Subject: Collin County Healthcare Facility, Parking Garage, and Medical Examiners
PCO No. 122; RFI #394 ME Phoenix Control Panel Requirements

Issue No. 122 - RFI #394 ME Phoenix Control Panel Requirements

RFI #394: ME - Phoenix Control Panels

1 M.E. PARTIAL FLOOR PLAN - AREA A - POWER
1/4" = 1'-0"

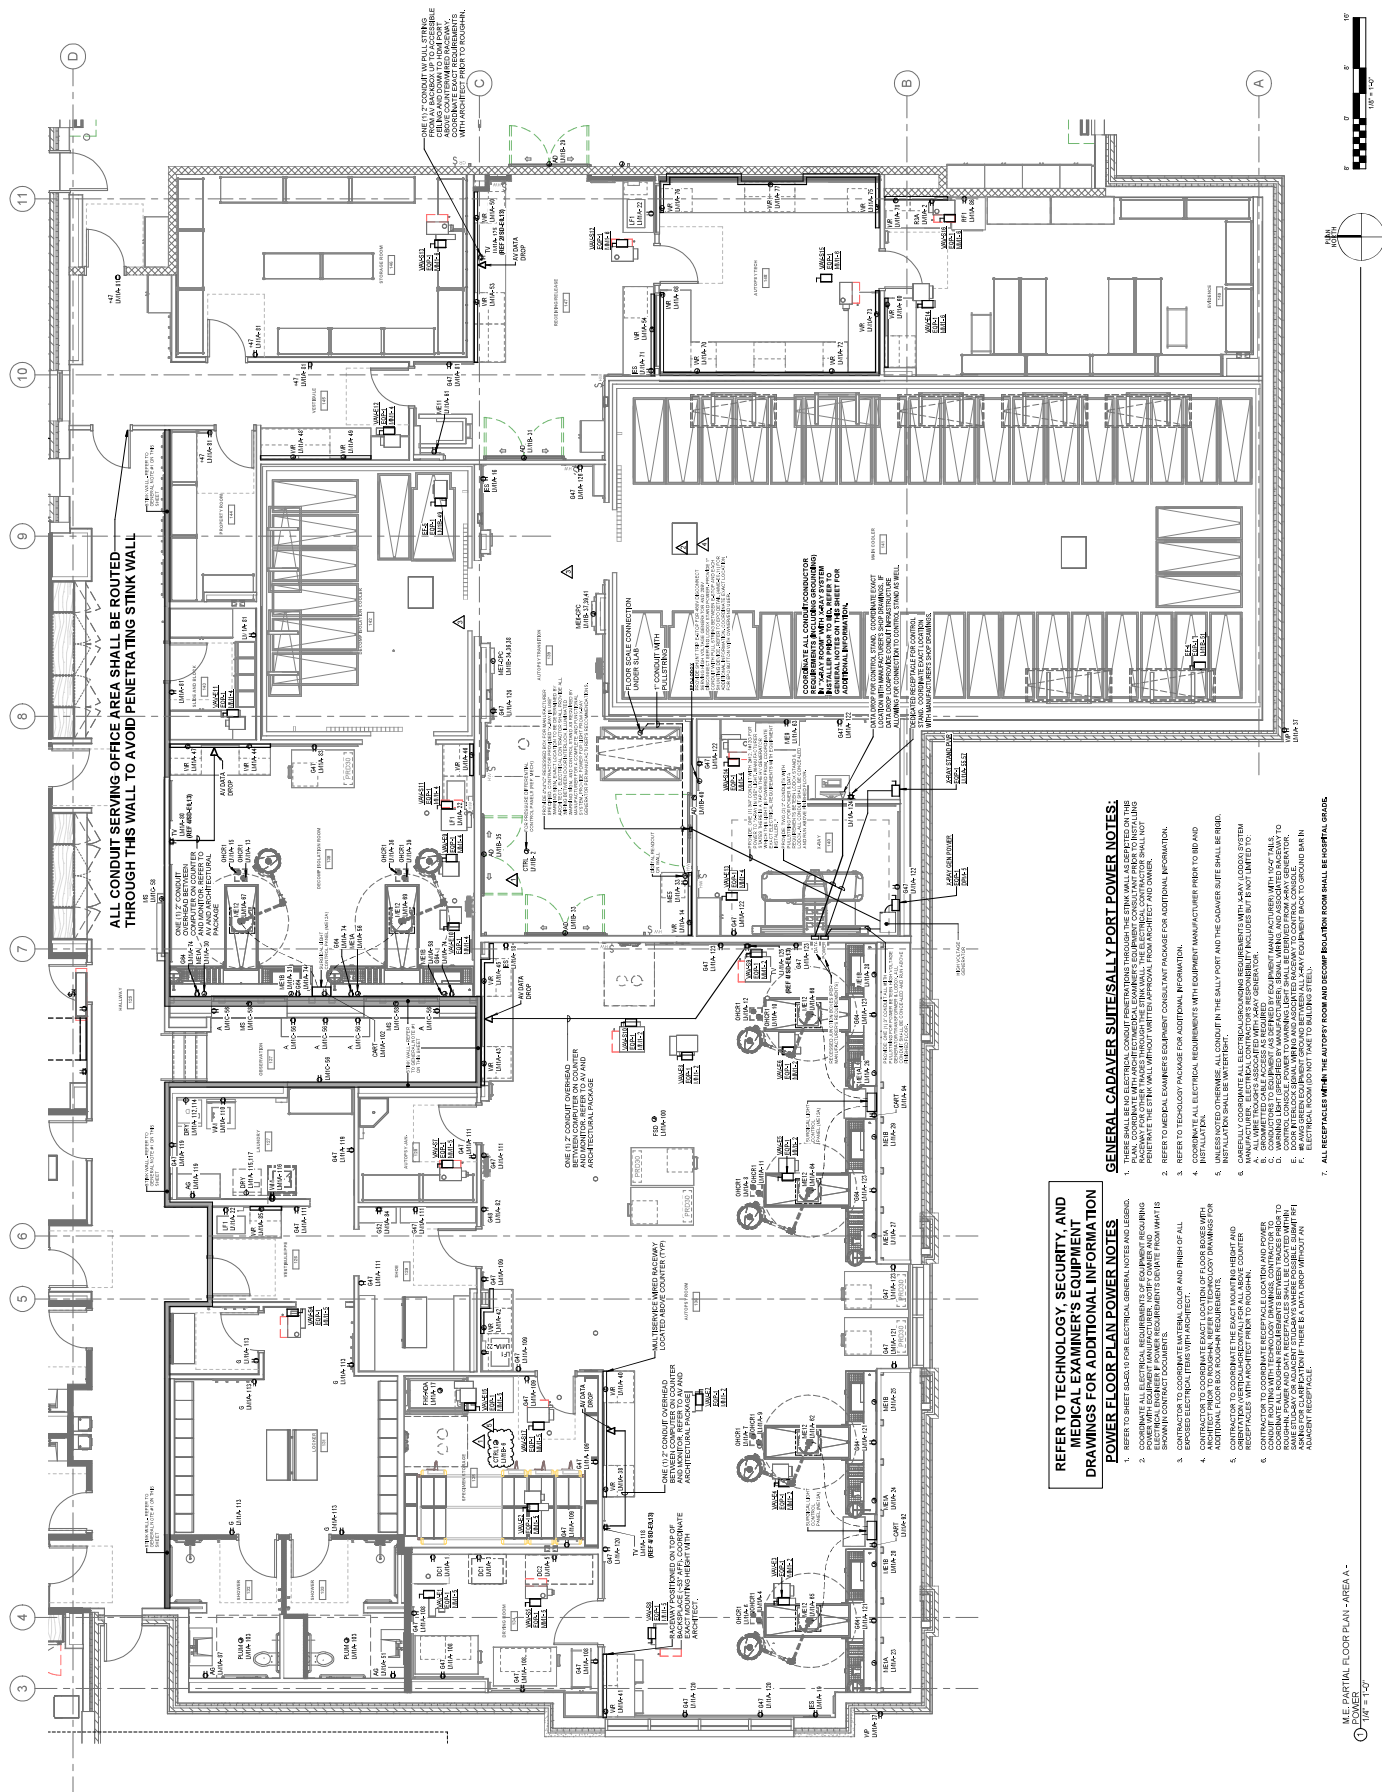
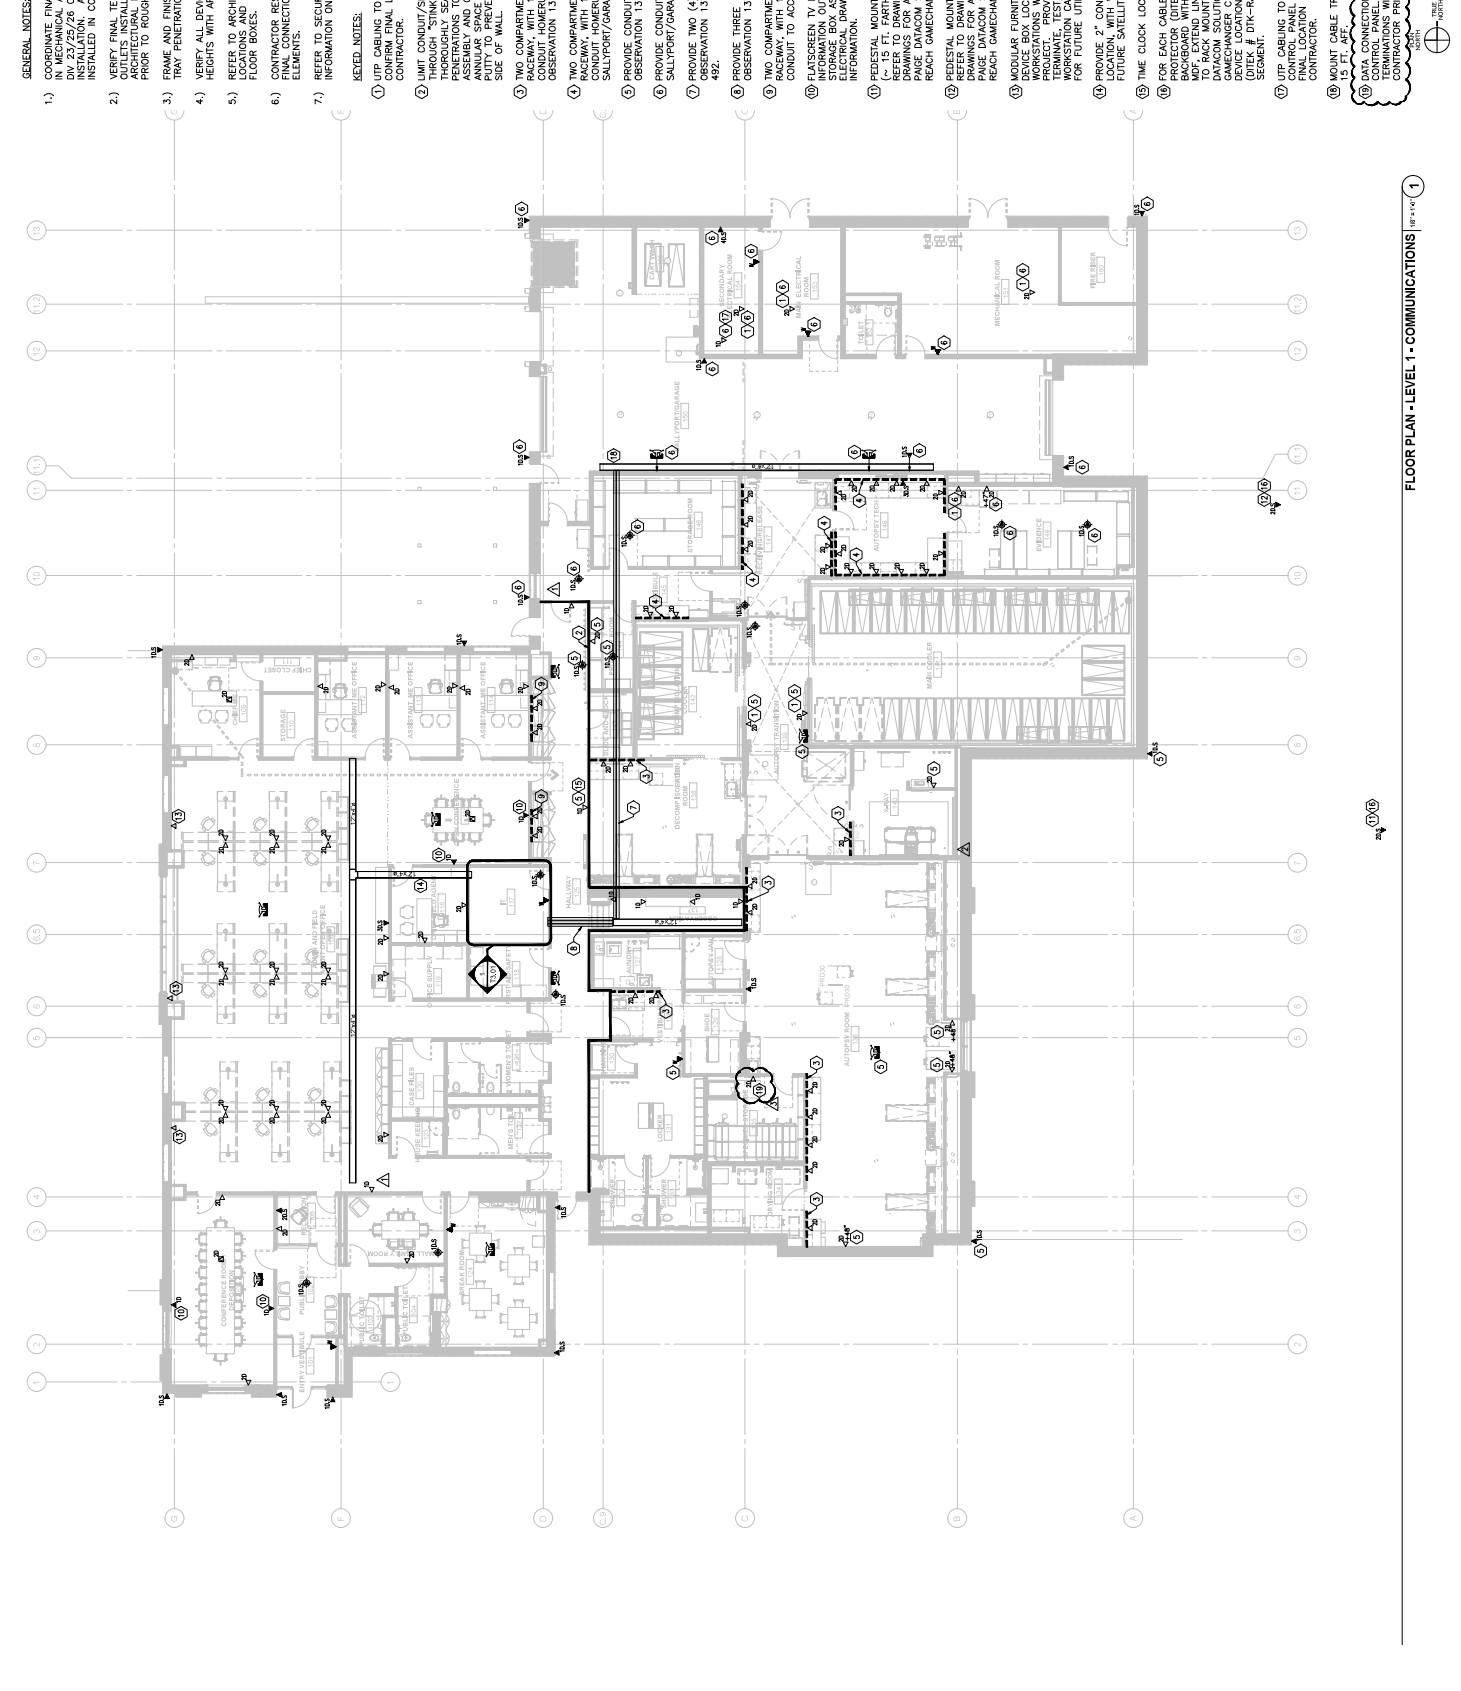
- In the MEB, a Phoenix control panel has been identified that requires a dedicated 120V 20A circuit. The electrical subcontractor is requesting clarification on whether this panel may be connected to the existing circuit serving Fume Hood LM1A-17 or to receptacle LM1A-109.

- Please confirm if this is acceptable or please provide an alternate solution.

- The current electrical drawings do not reflect the additions associated with ASI 03 for the Phoenix control panels. The sheets do not show the required electrical and datacom circuits for these control boxes.

- Please provide the missing information and confirm which electrical and datacom circuits are to be used for the Phoenix Control panels.

- Please provide an additional details in the form of a revised sheet.

1. HTC Level 1 floor plan- Provide labor and material to install one 20A dedicated circuit from panel LM1B to the Phoenix Control Panel as shown on the drawing provided.
2. Price includes using the existing 20A spare breaker in panel LM1B

FLOOR PLAN - LEVEL 1 - COMMUNICATIONS (18" x 11")

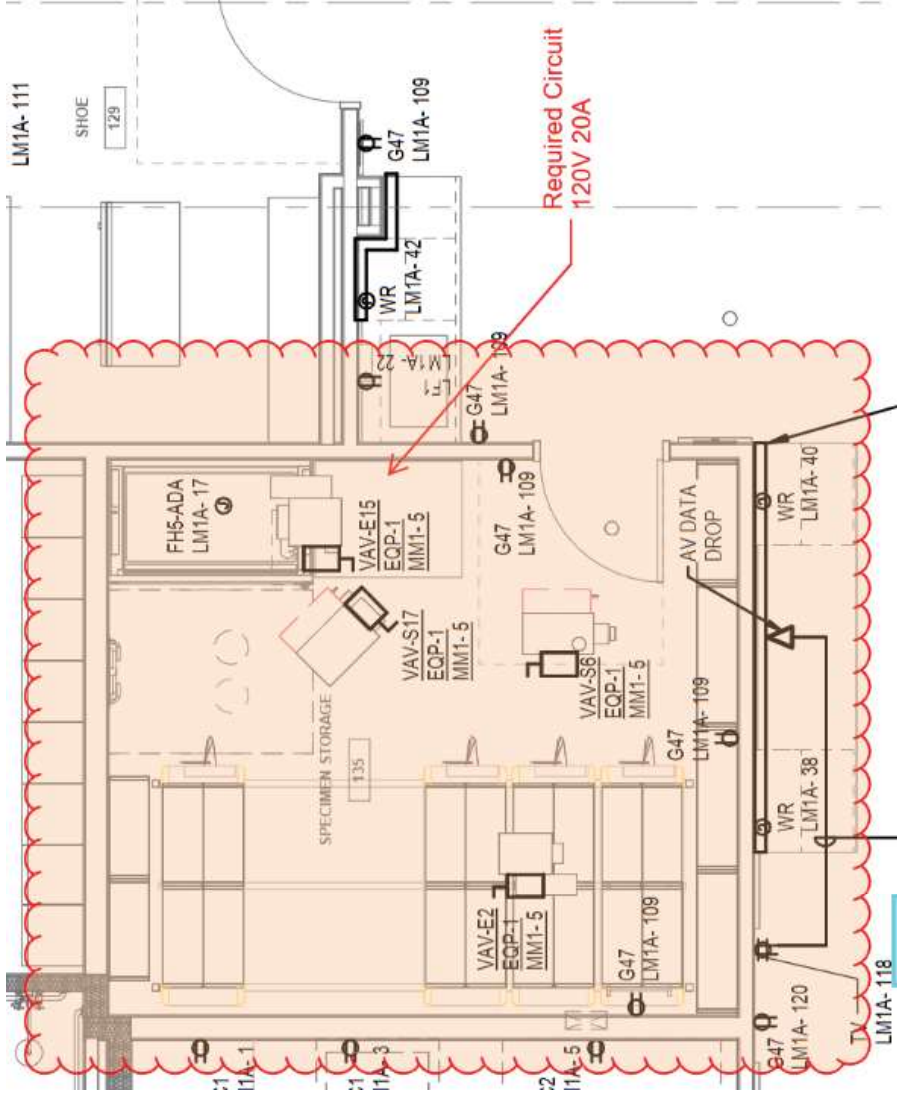
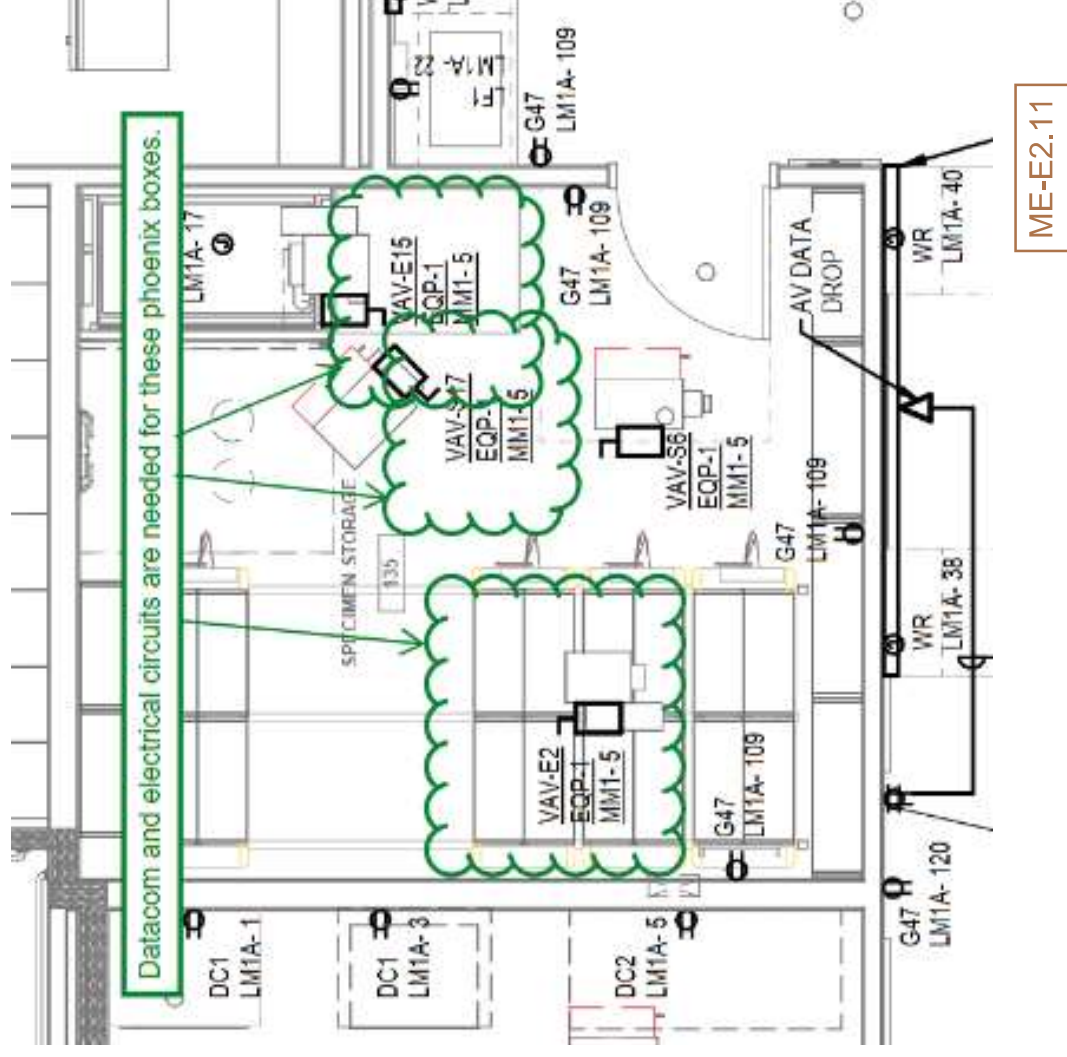
- In the MEB, a Phoenix control panel has been identified that requires a dedicated 120V 20A circuit. The electrical subcontractor is requesting clarification on whether this panel may be connected to the existing circuit serving Fume Hood LM1A-17 or to receptacle LM1A-109.
- Please confirm if this is acceptable or please provide an alternate solution.

- The current electrical drawings do not reflect the additions associated with ASI 03 for the Phoenix control panels. The sheets do not show the required electrical and datacom circuits for these control boxes.
- Please provide the missing information and confirm which electrical and datacom circuits are to be used for the Phoenix Control panels.
- Please provide an additional details in the form of a revised sheet.

- 19) DATA CONNECTION TO SERVE PHOENIX COMMUNICATIONS. PROVIDE 1/2" MIN. THICK PUTTY TO PREVENT ODOR EGRESS TO OFFICE SIDE OF WALL. PROVIDE DRAWINGS FOR ADDITIONAL DETAILS. PROVIDE PAGE DATACOM SOLUTIONS, EXTENDED REACH DATACOM OSP RATED CABLE.

- Provide and Install (2) Category 6 Cables for Phoenix Control Panel Location.
- Terminate/Test/Label
